# Brookline Preservation Commission

## Local Historic District Report

**Local Historic District:** Graffam-McKay

**Address:** 31 Osborne Road

Front and side views of proposed columns and balusters

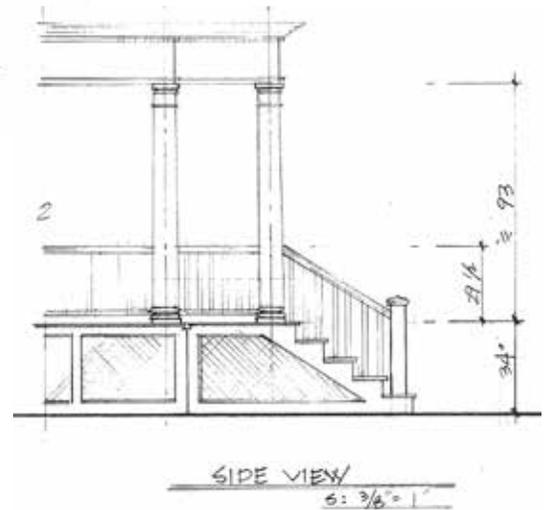
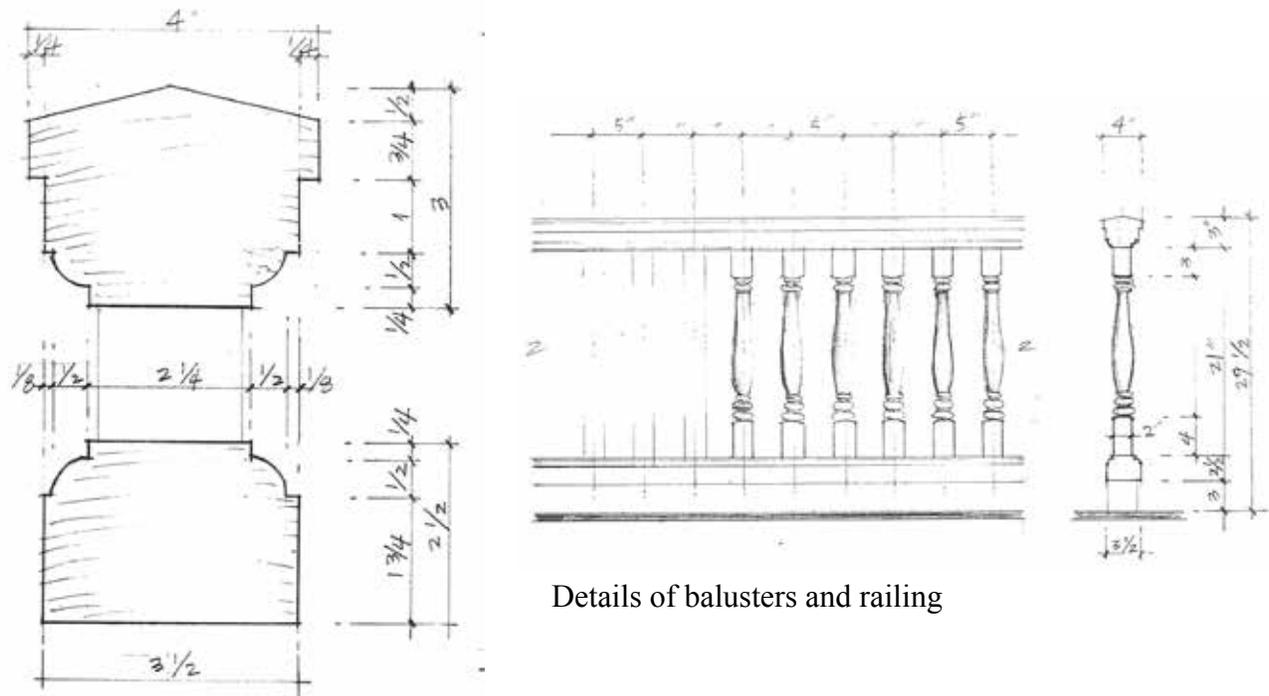
**Proposed Alterations:** Application for a Certificate of Appropriateness to remove existing columns and railings on front porch and replace with columns and railings to match original elements in neighborhood. and to rebuild side porch with diamond lattice and posts to match rear porch.

**Preliminary Findings:** The applicant wants to restore the porch to a more appropriate design and height using original elements of the houses in the area.

rebuild side porch with similar posts to rear porch and railings- replace square lattice with small diamond shaped lattice
